Comments/suggestions received on the NEERI, NGRI and IICT reports related to Bhopal Gas Leak Disaster

S.No.	Details	Page No
1.	Dr. P.S.Goel, President, Indian National Academy of Engineering, New Delhi	2 - 4
2.	Dr.Dilip B.Boralkar, Deonar, Mumbai	5 - 13
3.	Dr. M.Sengupta, Former Adviser, MoEF	14 - 37

Figure 1: Variation of carbaryl content as function of soil organic content for soils in UCIL premises (data from Tables 20 and 28, NEERI 2010)

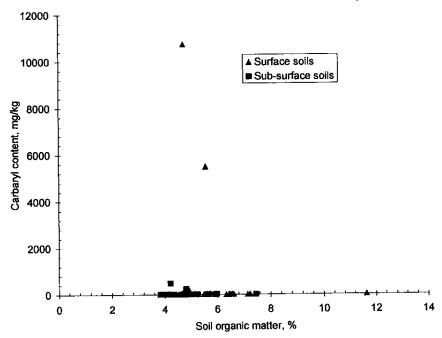
Soil organic matter (SOM) is often considered the dominant sorptive phase for organic contaminants and pesticides in soil-water systems (Sheng et al., 2001). Lafleur (1976) confirmed the overriding restraint imposed by organic matter content on cabaryl desorption and movement in soil columns. Sharom et al., (1980) and Jana and Das (1997) indicate that soil organic matter is a contributor to sequestering carbaryl in soils; these workers observed that a soil's resistance to water leaching of carbaryl and its sorption capacity for this pesticide increases with the soil organic content. Data reported in Table 28 (NEERI 2010) reports unusually large values of organic carbon content (3 to 12 %) for the surface and sub-surface (30 cm depth) black soil samples in UCIL plant premises. The soil in the UCIL campus is formed by in-situ weathering of basalt rock. Typically organic matter of < 2 % is obtained for such residually derived black soils (Bhattacharyya et al., 2007). Despite the high organic content, a poor correlation emerges between SOM and carbaryl content for the surface and sub-surface soil samples in UCIL premises (Figure 1, data extracted from Tables 20 and 28, NEERI 2010). Based on the earlier reported studies on soil organic matter and pesticide retention, the amount of pesticide (carbaryl) retention was expected to positively correlate with soil organic content in Figure 1.

The unusually high range of SOM (3 to 12 %) cannot possibly be ascribed to soil contamination by organic chemicals as similar range of SOM (Table 17, NEERI 2010) is reported for the uncontaminated upstream and downstream soil samples (Tables 11 to 16, NEERI 2010).

Figure 1: Variation of carbaryl content as function of soil organic content for soils in UCIL premises (data from Tables 20 and 28, NEERI 2010)

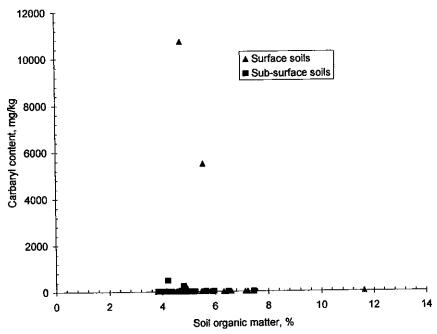
Soil organic matter (SOM) is often considered the dominant sorptive phase for organic contaminants and pesticides in soil-water systems (Sheng et al., 2001). Lafleur (1976) confirmed the overriding restraint imposed by organic matter content on cabaryl desorption and movement in soil columns. Sharom et al., (1980) and Jana and Das (1997) indicate that soil organic matter is a contributor to sequestering carbaryl in soils; these workers observed that a soil's resistance to water leaching of carbaryl and its sorption capacity for this pesticide increases with the soil organic content. Data reported in Table 28 (NEERI 2010) reports unusually large values of organic carbon content (3 to 12 %) for the surface and sub-surface (30 cm depth) black soil samples in UCIL plant premises. The soil in the UCIL campus is formed by in-situ weathering of basalt rock. Typically organic matter of < 2 % is obtained for such residually derived black soils (Bhattacharyya et al., 2007). Despite the high organic content, a poor correlation emerges between SOM and carbaryl content for the surface and sub-surface soil samples in UCIL premises (Figure 1, data extracted from Tables 20 and 28, NEERI 2010). Based on the earlier reported studies on soil organic matter and pesticide retention, the amount of pesticide (carbaryl) retention was expected to positively correlate with soil organic content in Figure 1.

The unusually high range of SOM (3 to 12 %) cannot possibly be ascribed to soil contamination by organic chemicals as similar range of SOM (Table 17, NEERI 2010) is reported for the uncontaminated upstream and downstream soil samples (Tables 11 to 16, NEERI 2010).
